Subject: Braidwood Station Unit 1  
NRC Docket Number 50-456

Response to Request for Additional Information Pertaining to Operating Interval  
Between Eddy Current Inspections for Circumferential Indications in the  
Braidwood Unit 1 Steam Generators

Figure 1a. Industry Tube Pull/Insitu Indication Average Volts vs. Maximum Volts

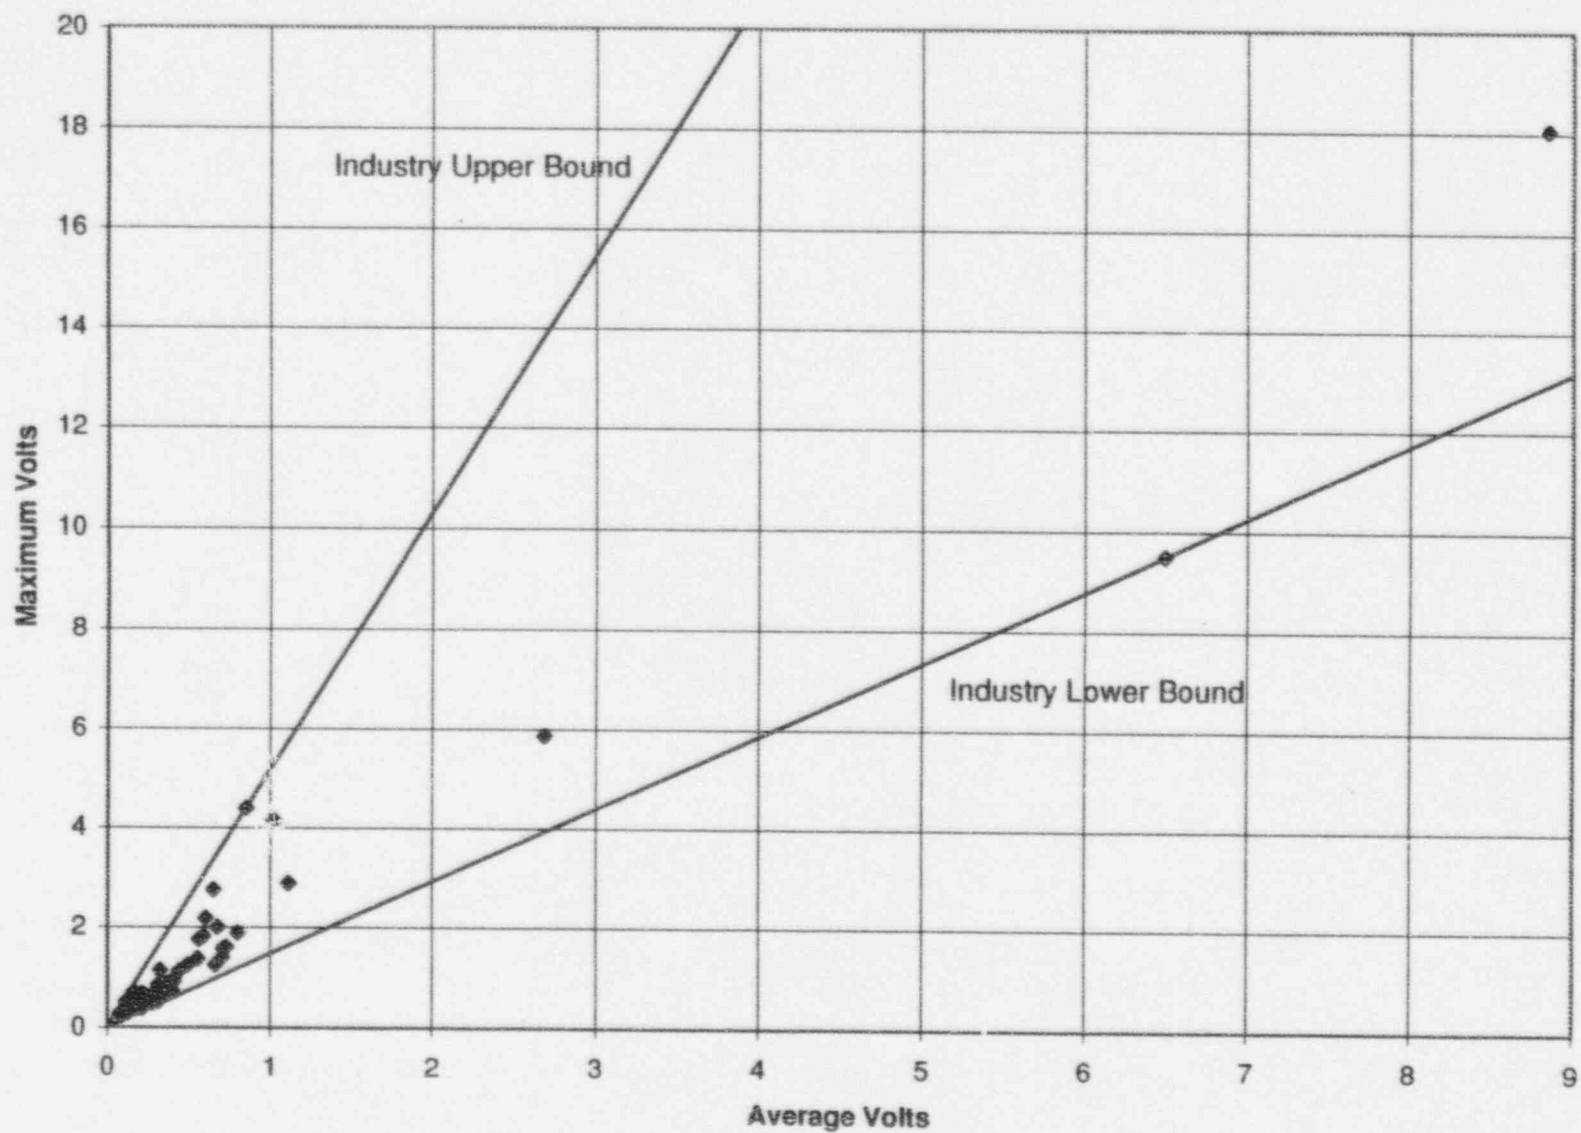
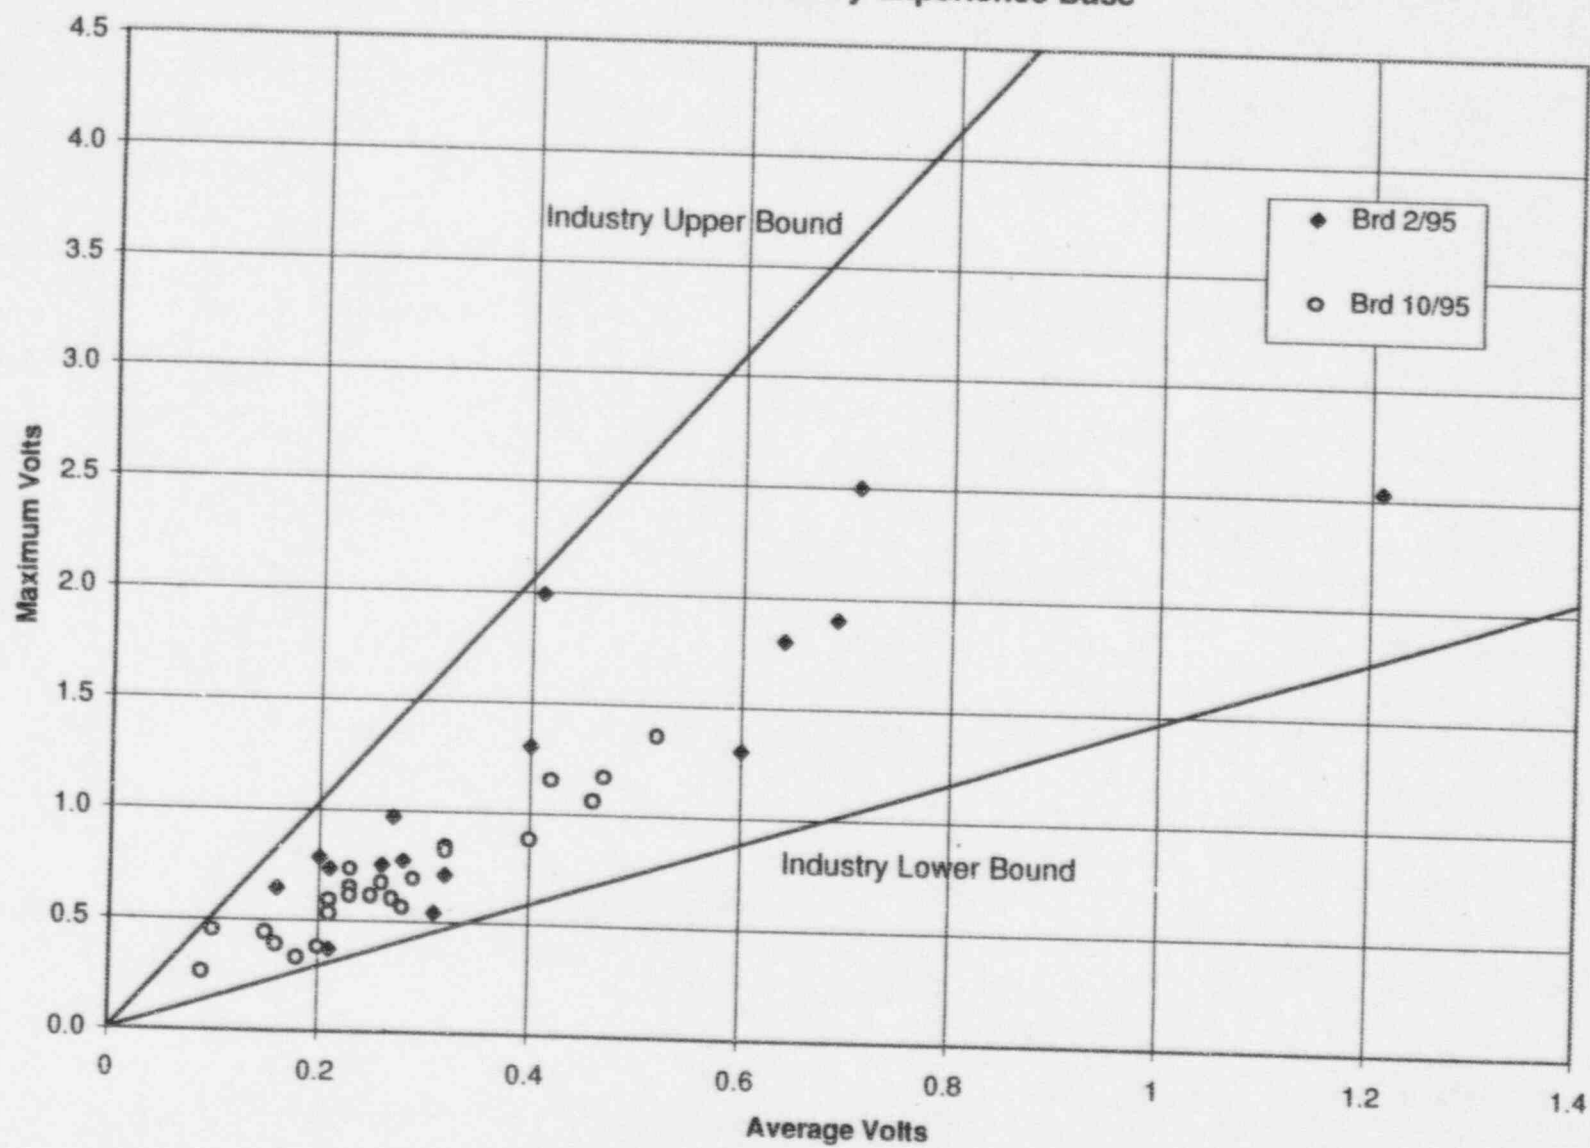
1. In the license's submittal dated August 2, 1996, a morphology assessment was provided which attempts to demonstrate the similarity between circumferential crack indications in Braidwood, Unit 1 to Byron, Unit 1 based on the relationship between the maximum and the average eddy current (EC) voltages. However, the licensee did not provide a sufficient basis for assuming an eddy current voltage assessment is indicative of degradation morphology. Accordingly, provide data supporting the assumption that circumferential flaws (either real and/or simulated) with morphologies different from that found at Byron Unit 1 demonstrate a different and clearly distinct relationship between the average and the maximum EC voltage such that differing morphologies could be distinguished.

Additional NDE confirmation that the Braidwood Unit 1 circumferential indications are within the Byron Unit 1 and industry experience base is provided by the plots of EC maximum versus average voltage in Figures 1a and 1b. Figure 1a shows the industry data base for pulled tubes (56 data points) and the bounds that encompass the data. These data include data from Byron Unit 1. These data also include a range of degradation levels including a tube where the percent degraded area (PDA) was approximately 94% (also see response to Question 9). Figure 1b shows a comparison of the bounds for the industry experience with the indications detected during the February 1995 and October 1995 inspections at Braidwood 1. A comparison of the industry experience base, as represented by the bounding lines, with the Braidwood indications provides additional confirmation that the morphology at Braidwood Unit 1 is within the industry experience base. Three conclusions are reached based on Figures 1a and 1b.

**Figure 6a. Maximum Voltage vs. Adjusted Insitu or Burst Pressure**

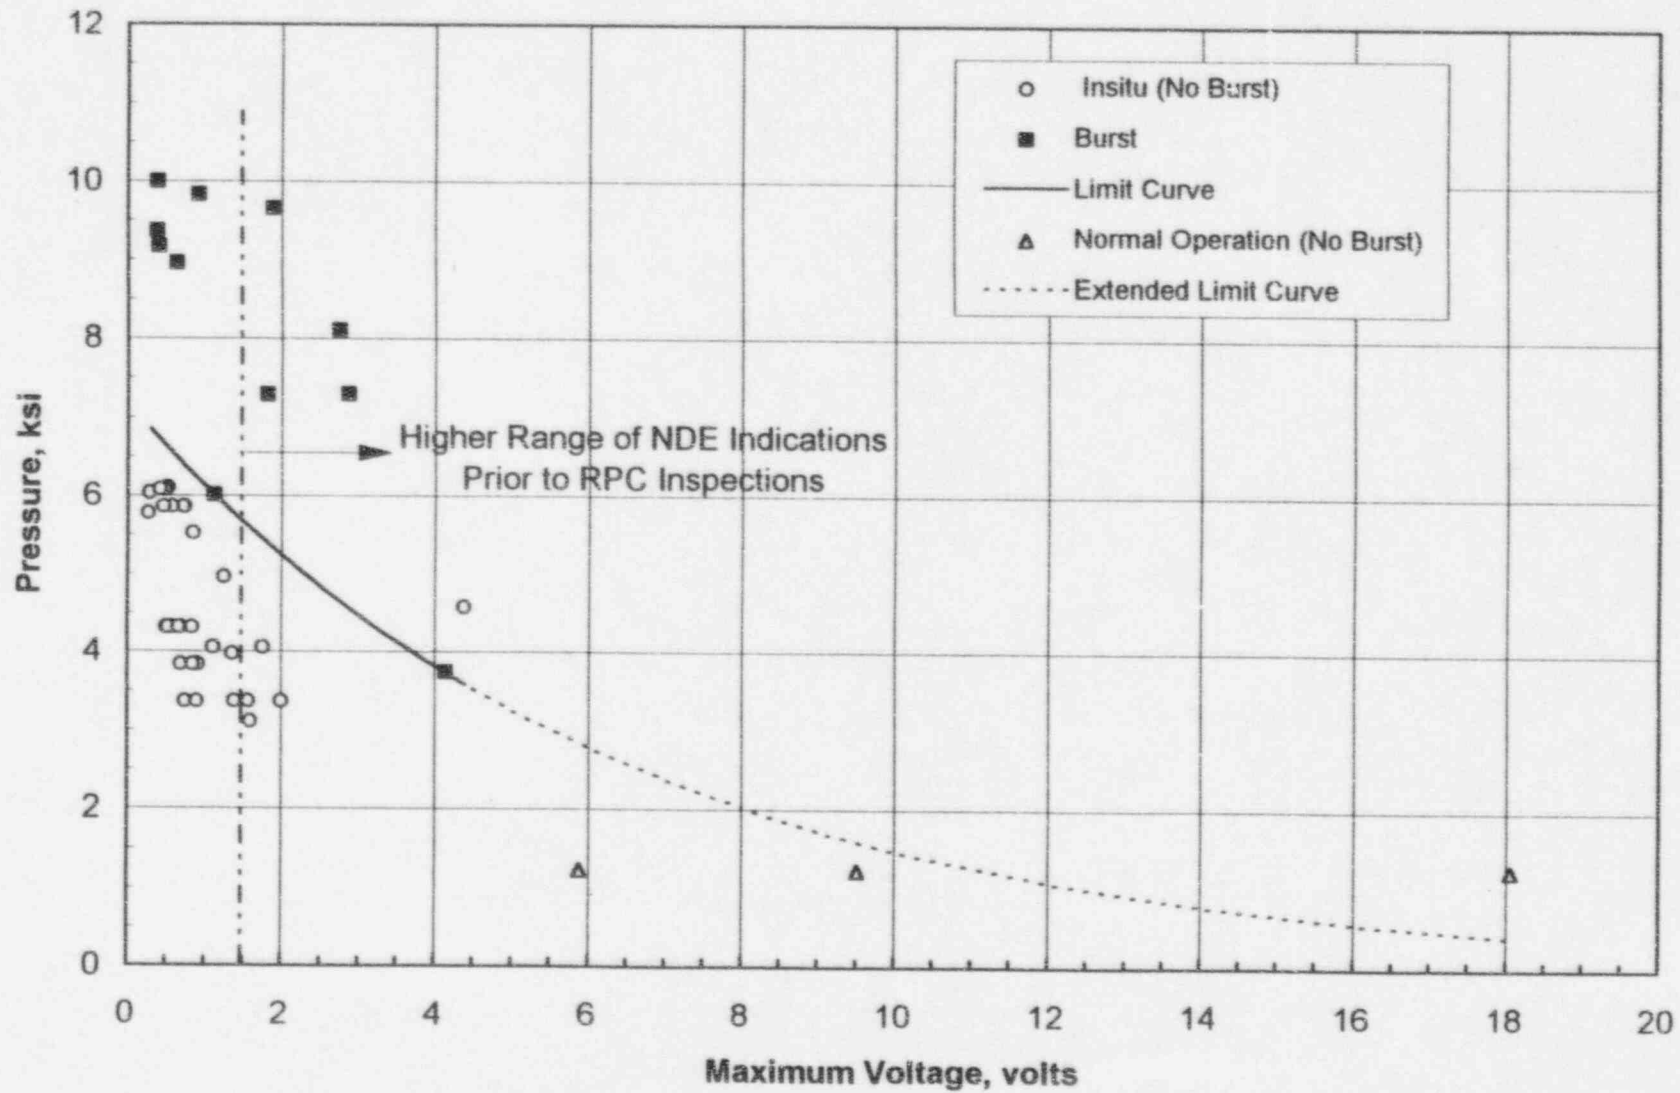
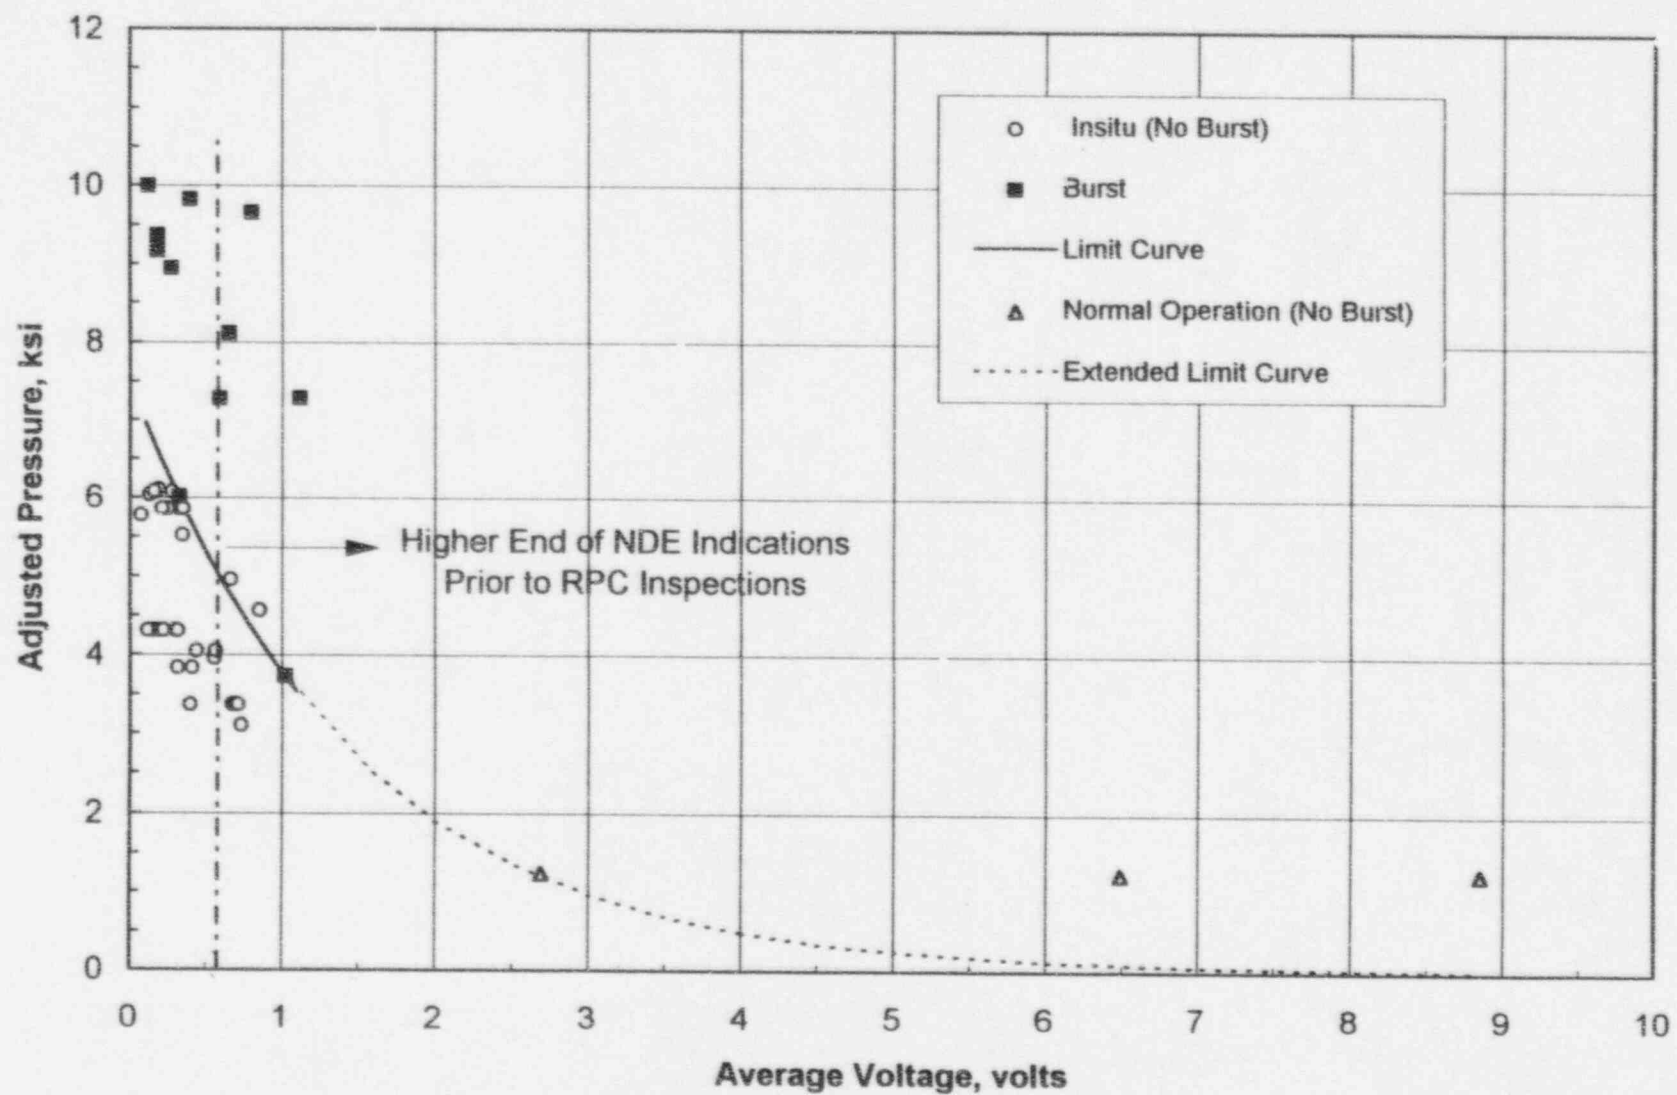
Response (9/17/96):

This is illustrated in Figures 6a and 6b, where burst pressure is plotted as a function of maximum and average voltage, respectively. The tubes corresponding to the three high voltage points in the figures were not burst or insitu pressure tested, and the plotted pressures for these three tubes are normal operating differential pressures (see data presented in response to Question 5). The pressure differentials shown in the figures have been corrected for Industry LTL material properties. None of these three tubes burst at normal operating differential pressures.

The dashed lines in the figures are extensions of the limit curves and were drawn as a comparison with the high voltage points at normal operating pressure. The dashed portion of the limit curves show there is a gradual drop in burst pressure immediately beyond the voltage associated with the range of available burst data. The information in Figures 6a and 6b also provides further confirmation that the deterministic burst curves are conservative, especially for average voltage where extremely large margins are indicated at high voltages.
